Subject: **WATER AND WASTEWATER CAPACITY AVAILABILITY LETTER**
Harbor FTL – DRC Case No. UDP-S23002
3013 Harbor Drive, Fort Lauderdale, FL 33316

City of Fort Lauderdale
Public Works Department
Water and Wastewater Capacity Analysis

Harbor FTL – DRC Case No. UDP-S23002
3013 Harbor Drive, Fort Lauderdale, FL 33316

Figure 1 – City Water Atlas

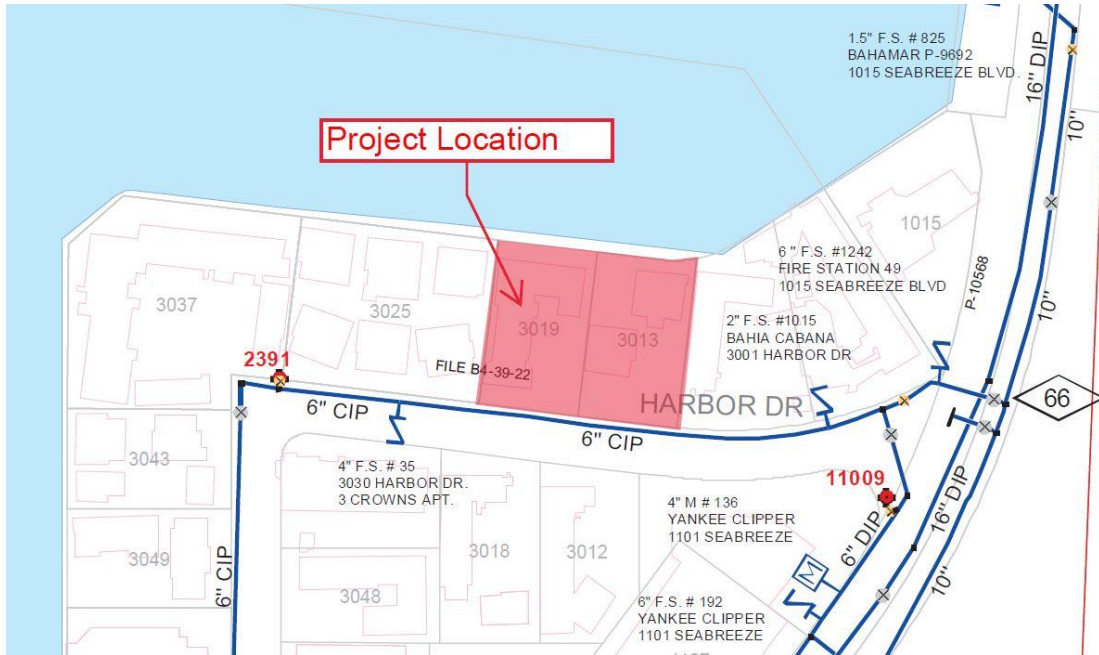
Water: The site is currently served by a 6-inch water main along Harbor Drive, south of the project site. See Figure 1.

Evaluation of impact on existing distribution pipe: According to the site plan, the applicant is proposing to utilize the 6-inch water main along Harbor Drive. The InfoWater hydraulic model was analyzed to determine the impact of this project on the existing 6-inch water main.

Recommended Water Infrastructure Improvements: No improvements required.

Figure 2 – City Sewer Atlas

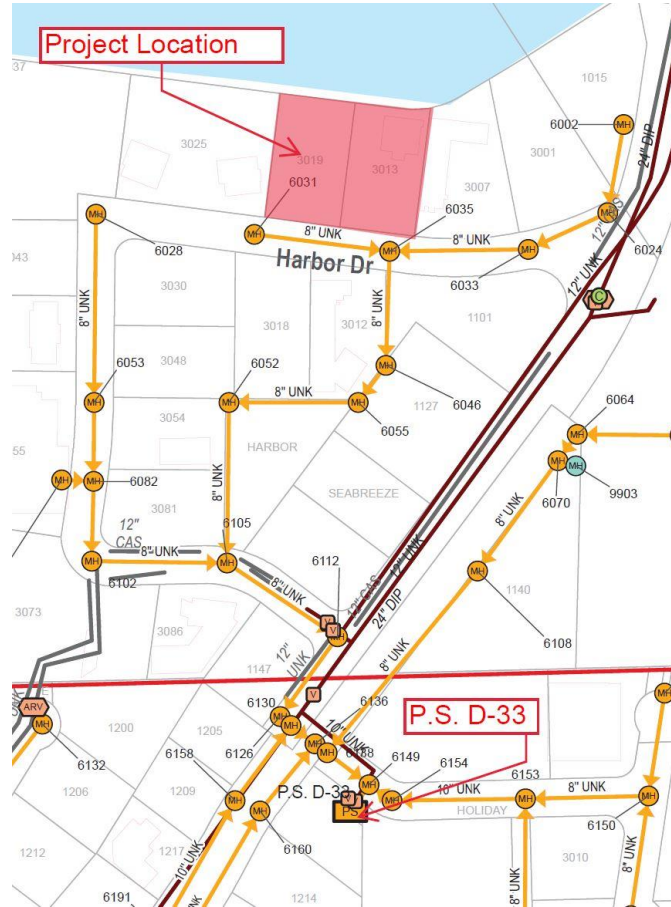
Wastewater: The site is currently served by an 8-inch gravity sewer main to south of the project site along Harbor Drive. See Figure 2.

Figure 3 – City Sewer Atlas Improvements

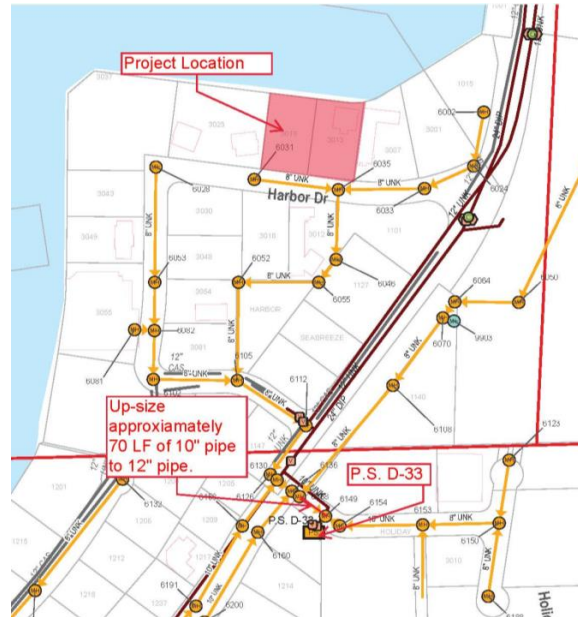
The existing water infrastructure has the capacity to support the proposed development. The sewer infrastructure requires improvements to meet the increased demand of the proposed project, see Figure 3.

Evaluation of impact on existing collection pipe: According to the site plan, the applicant is proposing to utilize the 8-inch gravity sewer main to south of the project site along Harbor Drive. Accounting for existing flows and based on the tools and information available to the City staff, it has been calculated that the pipes downstream of the proposed development will flow greater than the City's governance plan threshold of 70% during peak flows. Therefore, the pipes downstream of the developments are not adequate to serve the proposed project.

Recommended Wastewater Infrastructure Improvements: Prior to issuance of a Certificate of Occupancy, approximately 70 LF of new 10” to 12” pipe and improvements to the pump station will be required (see Figure 3).

Figure 5

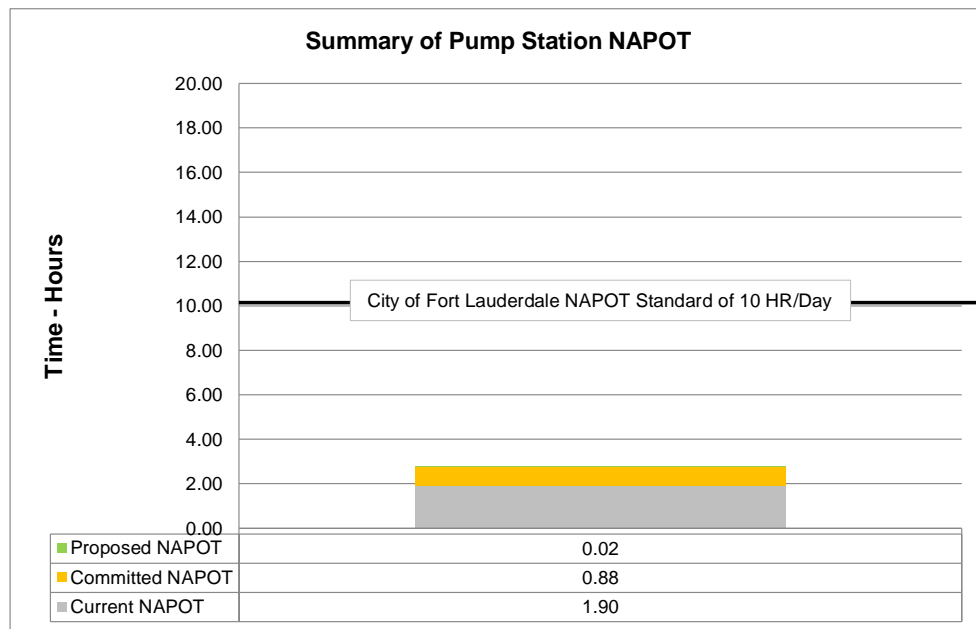
Evaluation of impact on pumping station: PS D-33 has a duty point of 1200 gallons per minute (GPM) and has a Nominal Average Pumping Operating Time (NAPOT) of approximately 1.90 hours per day. Based on projected sewage flows, the pumping run times would increase approximately 1 minutes per day. Additionally, there are other committed flows from proposed developments within the PS D-33 basin resulting in 52.87 minutes of additional runtime. PS D-33 will have a NAPOT of 2.80 hours once the proposed developments are complete, less than the recommended average of 10 hours per day. See Figure 5 below.
